SUBMITTAL SUMMARY REPORT 33354

PLAN NAME: HEARTLAND DENTAL OCALA FREEDOM

**MAJOR SITE PLAN
HEARTLAND DENTAL
STORE #TBD
AT
NWC OF SW 95TH ST & SW 57TH AVE
OCALA, FL 34476
MARION COUNTY PARCEL #: 35699-006-04**

225,085
 SHEET #
 12/23/2025
 DATE
 15 x 20
 SCALE
C6.0
 UTILITY PLAN

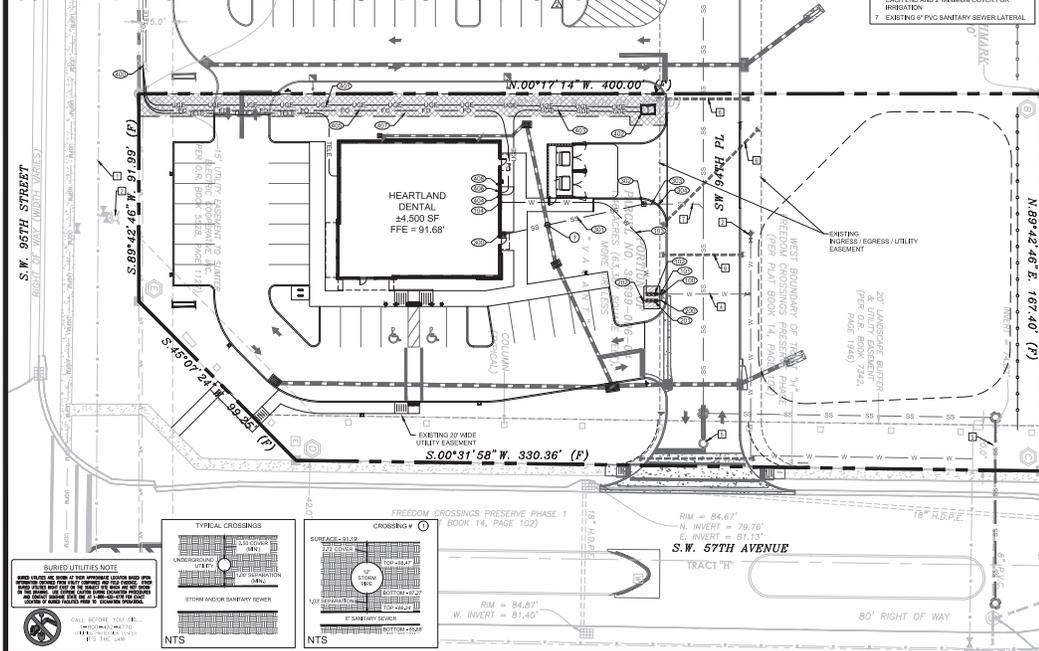
Corrections 6.14.4 - Capacity charges - irrigation (Resolved) - 6.14.4 - Capacity charges - irrigation: Projects using MCU irrigation shall must show the irrigation tap, meter placement, size, and backflow. Indicate total SF of irrigated area in anticipation of the irrigation meter request through Customer Service.

- NOTES:**
1. IRRIGATED AREA = 24,778 SF (65.67 AC)
- UTILITY PLAN KEYNOTES**
- WATER SERVICE CONNECTION**
100. REMOVE EXISTING 8" CPVC INSTALL 8" x 8" SPPS STEEL AND POLY TO PROPOSED WATER METER AND BRASS ASSEMBLY. CONTRACTOR SHALL VERIFY THE LOCATION & DEPTH OF EXISTING WATER MAIN BEFORE START OF CONSTRUCTION. REPORT TO ENGINEER IF ANY CONFLICT EXISTS. DETAIL: UT102, UT104, UT104 (C&U)
